# NorDig Unified Test Plan ver 2.5.0 tasks 3:10 and 3:49 Selection between identical services

Franck MANTEL | 16<sup>th</sup> March 2016

2/2

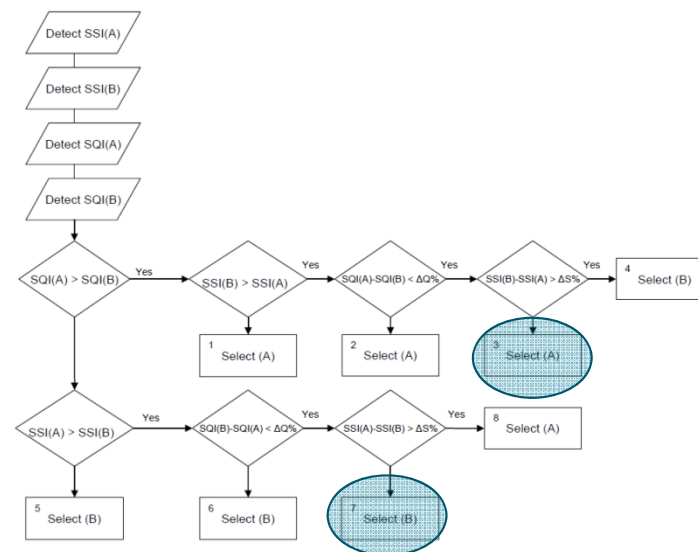
- Reference condition 3 requires **unexpected RSSI inaccuracy** such that SSI B > SSI A despite power level A > power level B. Assuming SSI A > SSI B, reference condition 1 is expected. **Could this be clarified?**
- Note that reference condition 7 requires power level of channels A and B much higher than QMP1 level to get same SQI for both channels while condition 5 requires same high power level (not compliant with test point 12) for both channels to get same SSI and SQI.
- As reference conditions 3 and 7 are validated in test points 23 and 27, it is expected that test point 14 validates conditions 5 or 1. **Could this be clarified?**
